South Texas Project
Units 1 and 2
Docket Nos. STN 50-498 and STN 50-499
Response to Request for Additional Information Regarding a
Proposed Amendment to Technical Specification 3.4.2.2

Reference: Letter, T. J. Jordan to NRC Document Control Desk, "License Amendment Request - Proposed Amendment to Technical Specification 3.4.2.2," dated May 22, 2003 (NOC-AE-03001454)

Response to Request for Additional Information

Figure 1

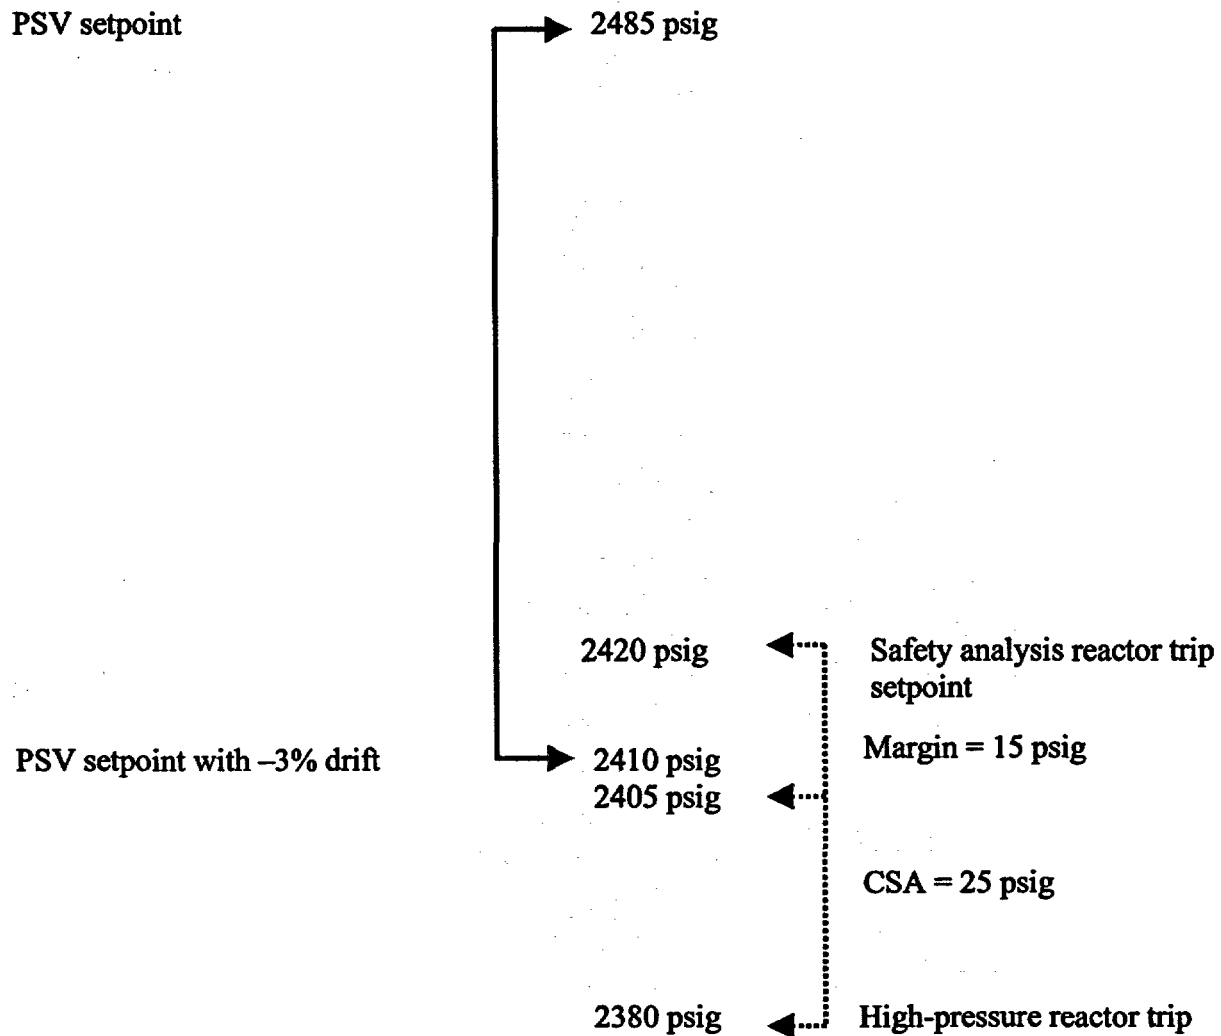
1. The current Technical Specification (TS) 3.4.2.2 requires that all pressurizer safety valves (PSVs) shall be operable with a lift setting of 2485 psig $\pm 2\%$. The proposed modification will change the lift setting to 2485 psig $+2\%$, -3% . The proposed TS has a potential PSV lifting pressure of 2410 psig which is lower than the high pressure reactor trip setting of 2427 psig (2380 psig $+2\%$ instrument uncertainties). Please discuss the effects of the PSV lifting prior to a reactor trip with respect to a) potential delay of a needed reactor trip, and b) unnecessary challenge to PSVs.

Figure 1 graphically depicts the setpoint and tolerance for the high-pressure reactor trip. The PSV setpoint and proposed lower operability definition of -3% are also depicted. All numbers are rounded to the nearest whole number for ease of discussion.

The reactor protection system (RPS) pressurizer pressure-high nominal trip setpoint is based on the safety analysis reactor trip setpoint of 2420 psig. The total allowance (TA) applied to the safety analysis reactor trip setpoint is 40 psig (5% of span), which establishes a nominal trip setpoint value of 2380 psig.

The TA term is composed of two main components. The first is the calculated channel statistical allowance (CSA), which for this parameter is 25 psig (3% of span). The second component is margin, which is 15 psig (2% of span) for this parameter.

Each PSV has a setpoint of 2485 psig. The amendment request proposes changing the lower operability definition from -2% to -3% (75 psig), which equates to 2410 psig. If during testing, the PSV lifts below 2410 psig, it is declared inoperable.

Because the 2410 psig PSV lower operability definition overlaps the safety analysis reactor trip setpoint of 2420 psig, the potential exists for the PSV to lift before the RPS pressurizer pressure-high trip actuates. However, as can be seen in Figure 1, if the CSA of 25 psig is applied to the pressurizer pressure-high nominal trip setpoint (2380 psig), the highest value expected for the trip to occur is 2405 psig. This value is still 5 psig less than the expected 2410 psig PSV lower operability definition when considering steady-state conditions.

During transient events that result in rapid RCS pressurization, it is possible for the PSV to lift prior to control rod insertion due to a reactor trip on pressurizer pressure-high signal. This is due to delays associated with the Reactor Protection System and reactor trip breakers. However, a reactor trip and control rod insertion would still occur, even with the current -2% lower operability definition. In addition, the -3% lower operability definition has been considered in accident analyses and the results show all acceptance criteria are satisfied. Therefore, the proposed change does not result in unnecessary challenges to the PSV.
